Docket Nos. 50-280  
 and 50-281 ✓

License Nos. DPR-32  
 and DPR-37

Change No. 8

Your letter dated July 5, 1973 enclosed proposed Technical Specification Change No. 8, which supersedes your proposed Technical Specification Change No. 8 requested in your letter of June 4, 1973. The proposed changes are required in order to implement a reduced primary system pressure program to preclude fuel collapse during the first fuel cycle.

Figure 2.1-2. Reactor Core Thermal and Hydraulic Safety Limits, Two Loop Operation, Loop Stop Valves Open

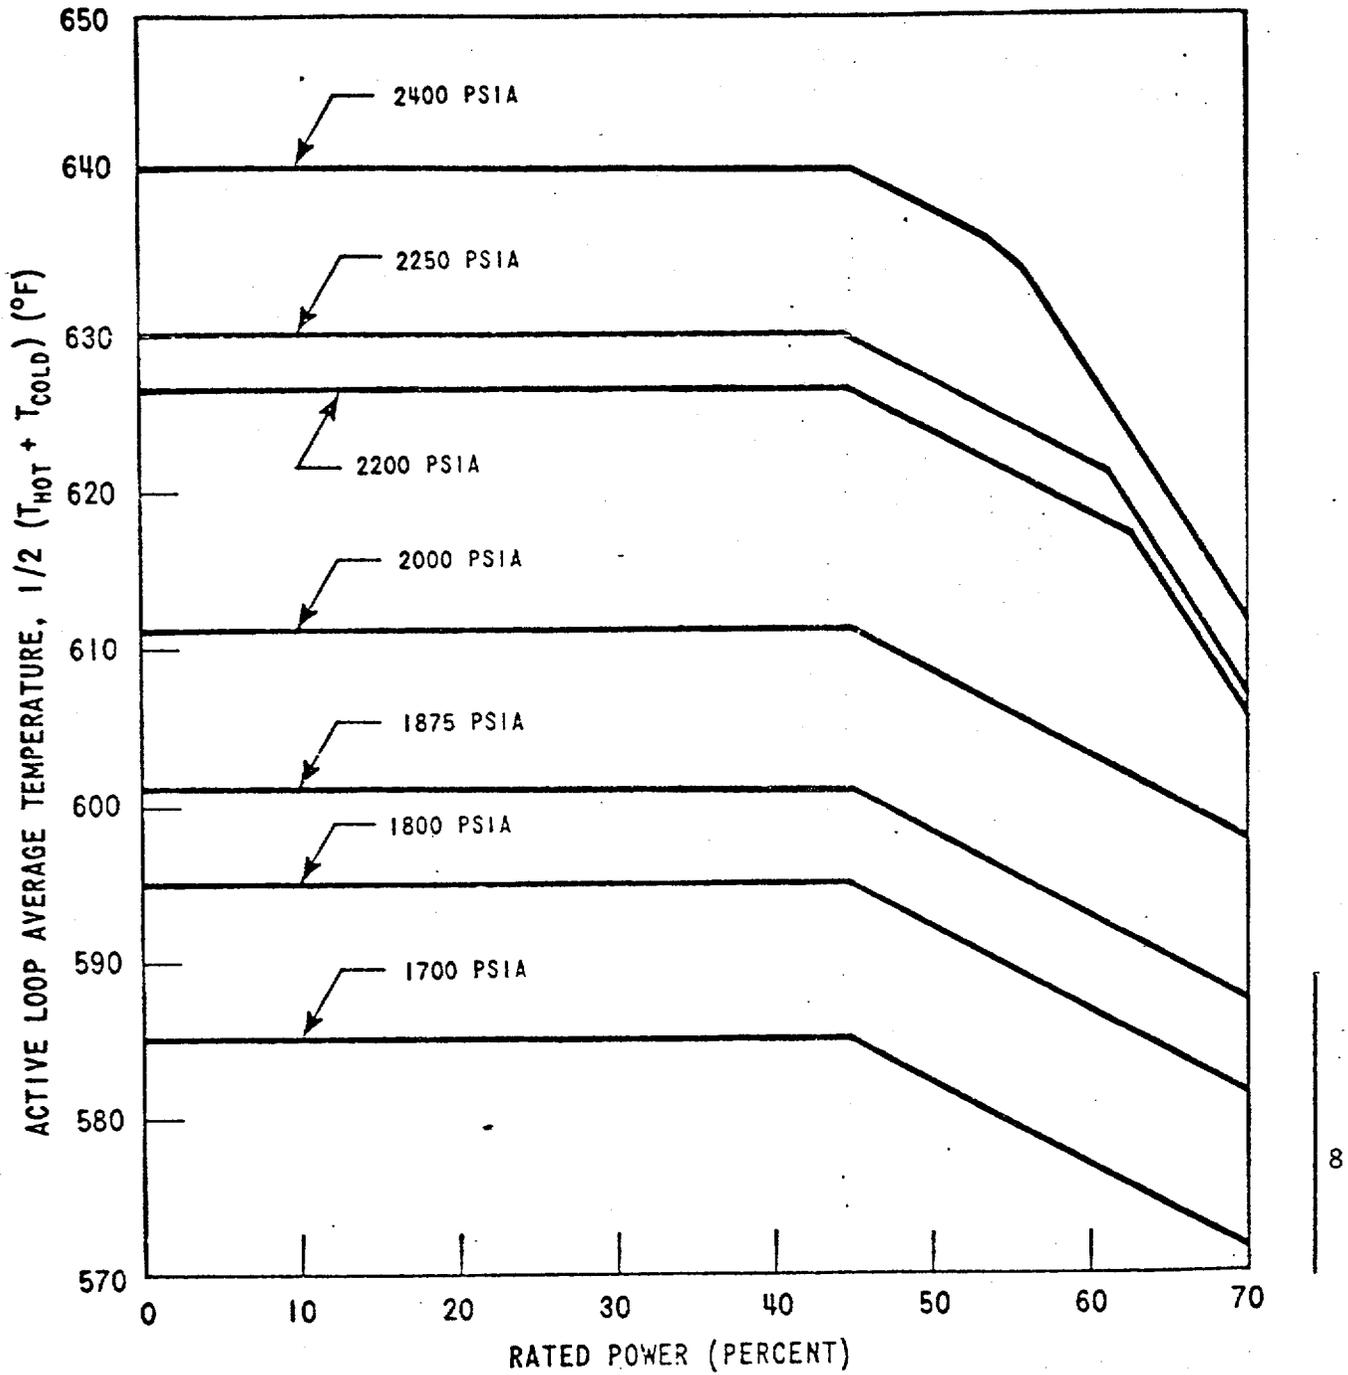
The overpower and overtemperature protection system setpoints have been revised to include effects of fuel densification and reduced pressure operation on core safety limits. The revised setpoints in the Technical Specifications will ensure that the combination of power, temperature, and pressure will not exceed

the revised core safety limits as shown in Figures 2.1-1, 2, and 3.

Figure 3.12-2 Control Bank Insertion Limits for 3 Loop Operation with One Bottomed Rod

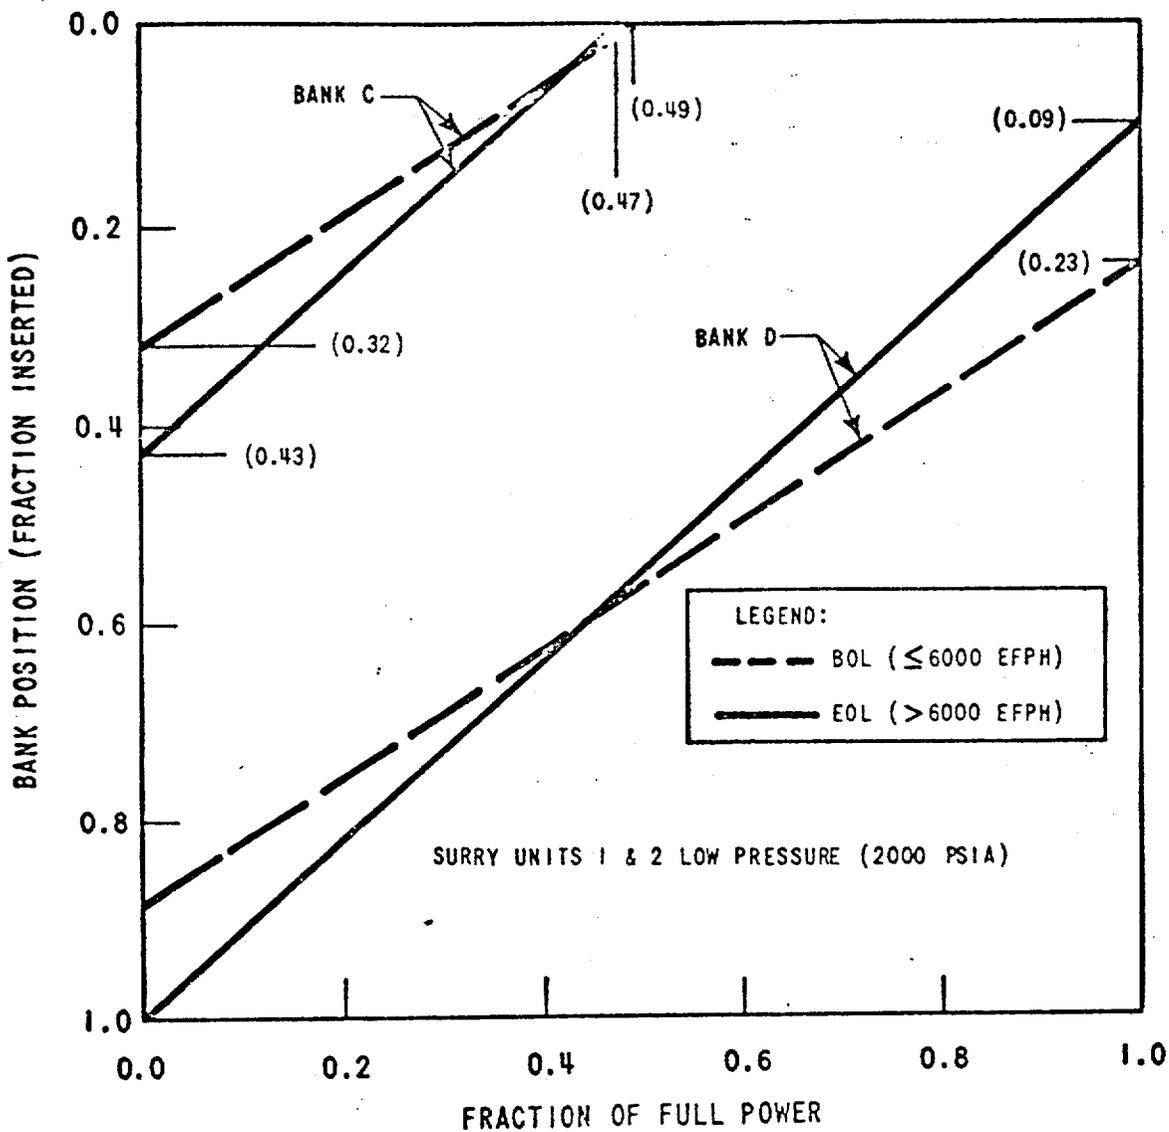
Accordingly, pursuant to Section 50.59 of 10 CFR Part 50, the Technical Specifications of Facility Operating License Nos. DPR-32 and DPR-37 are hereby changed as follows: replace pages TS Figure 2.1.1, TS Figure 2.1.2, TS Figure 2.1-3, TS 2.3-1, TS 2.3-2, TS 2.3-5, TS 2.3-6, TS Figure 3.12-1, and TS Figure 3.12-2 with the revised pages (designated as Change No. 8 on the bottom of the page) TS Figure 2.1-1, TS Figure 2.1-2, TS Figure 2.1-3, TS 2.3-1, TS 2.3-2, TS 2.3-5, TS 2.3-6, TS Figure 3.12-1, and TS Figure 3.12-2 enclosed.
